CITY OF NOVI CITY COUNCIL
NOVEMBER 17, 2025

SUBJECT: Consideration of tentative approval of The Grove PRO to rezone from Office Service Technology to Low Density Multiple Family with a Planned Rezoning Overlay. The applicant is proposing to develop a 232-unit multiple-family townhome development.

Typical Building Envelopes

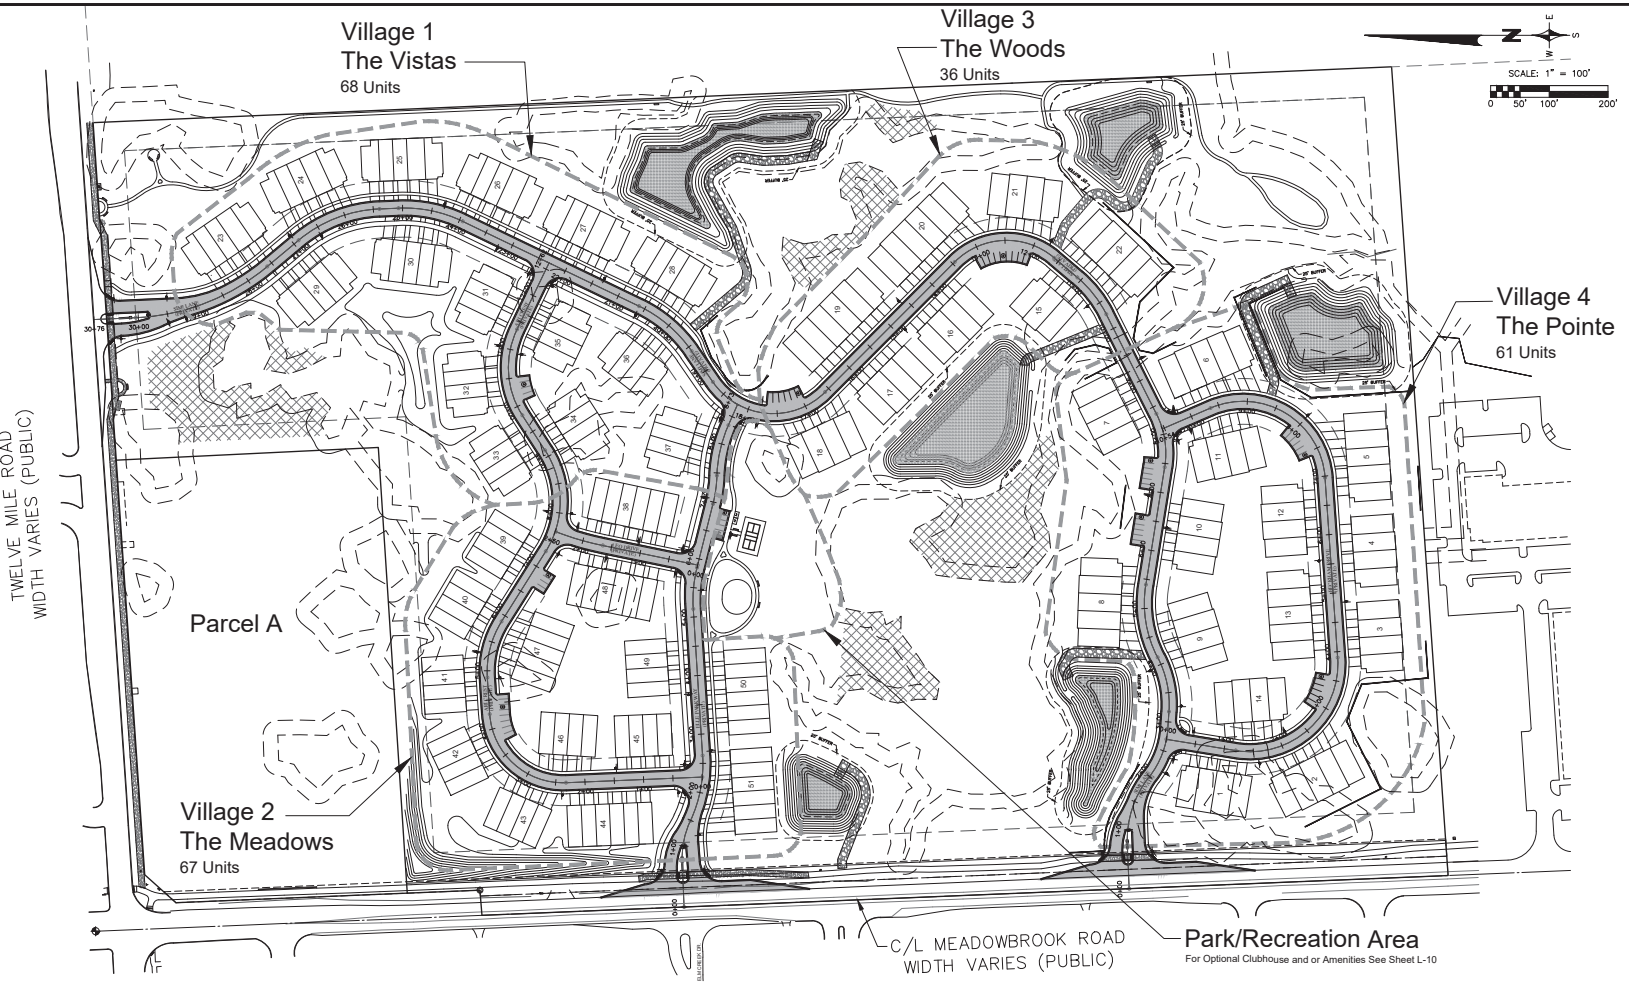
2. Sheet SP-3 indicates that decks and patios may extend a maximum of 10' beyond the building to envelope the perimeter of the building. Show deck and patios for each building to ensure there is no conflict with the detention basin drives, wetland buffers, or the retaining walls.

CITY BUILDING SEPARATION TABLE

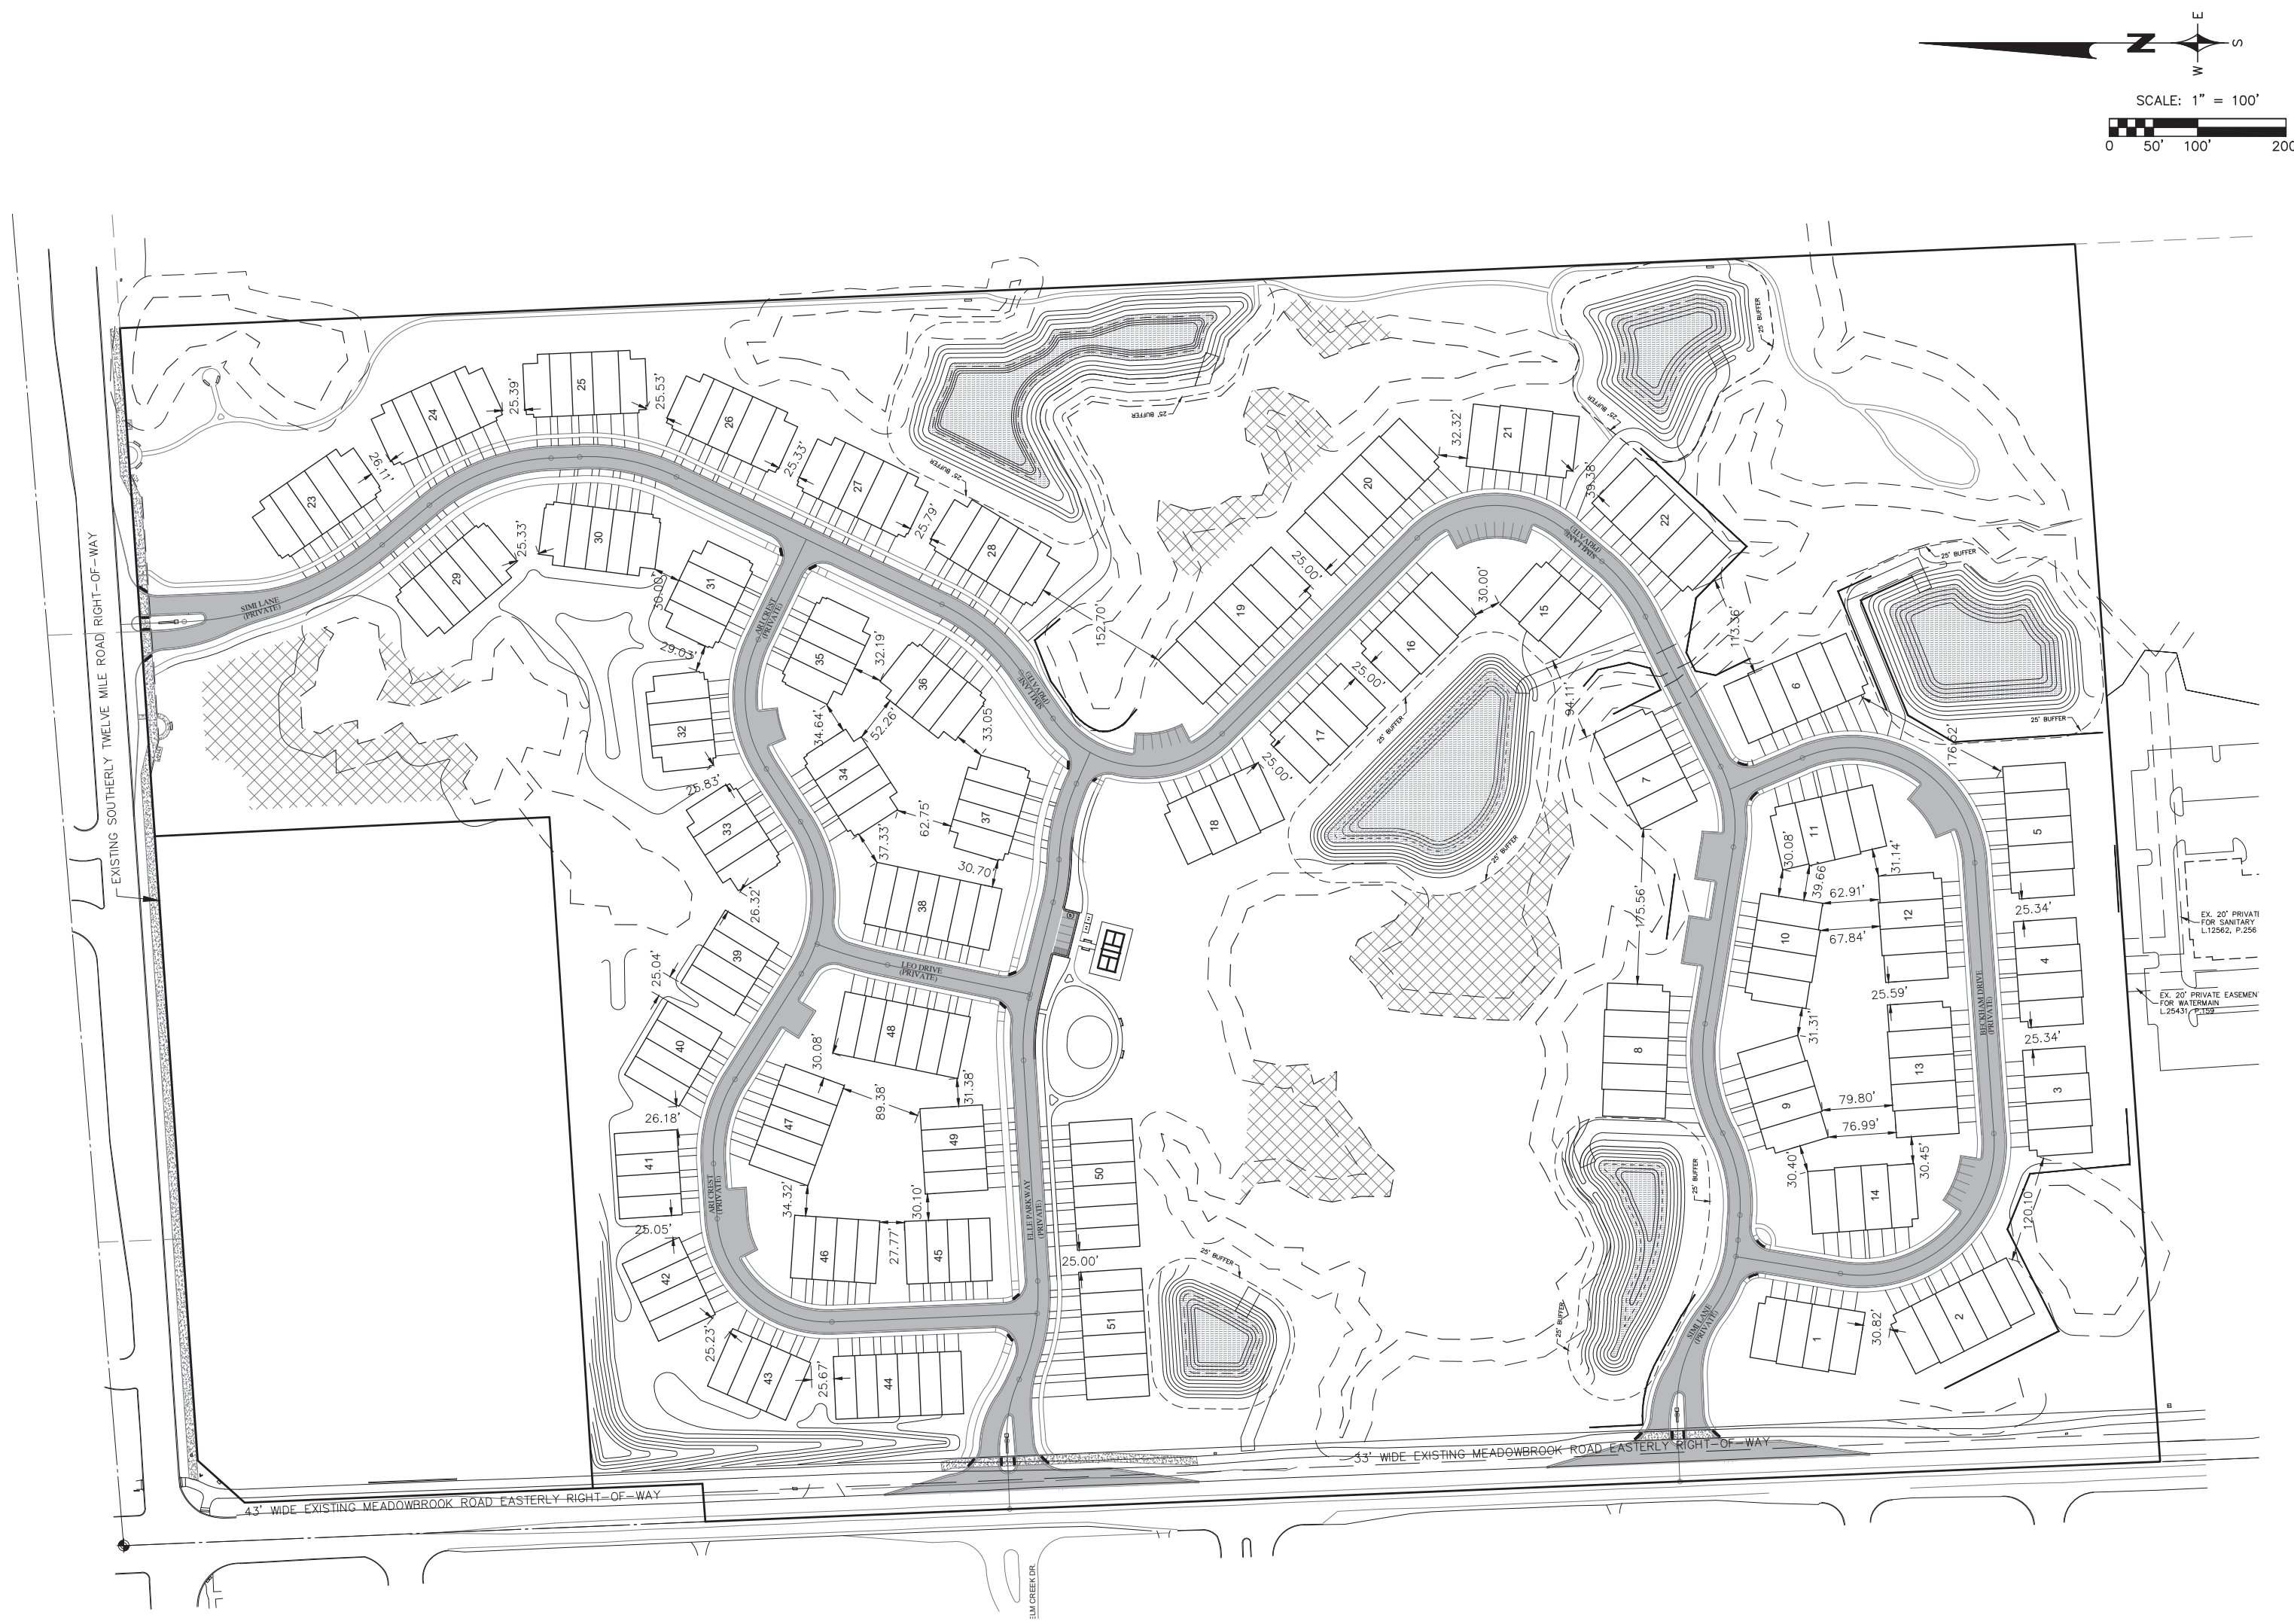
3. **Distance between Buildings** *(Sec 3.8.2.H): A Zoning Ordinance deviation is requested to reduce the building separation distance from the calculated formula as shown on the Building Separation Table on Sheet SP-3.6 of the PRO Plan).* **This deviation enables the layout of this project to fit within the available space while minimizing wetland and woodland impacts.**
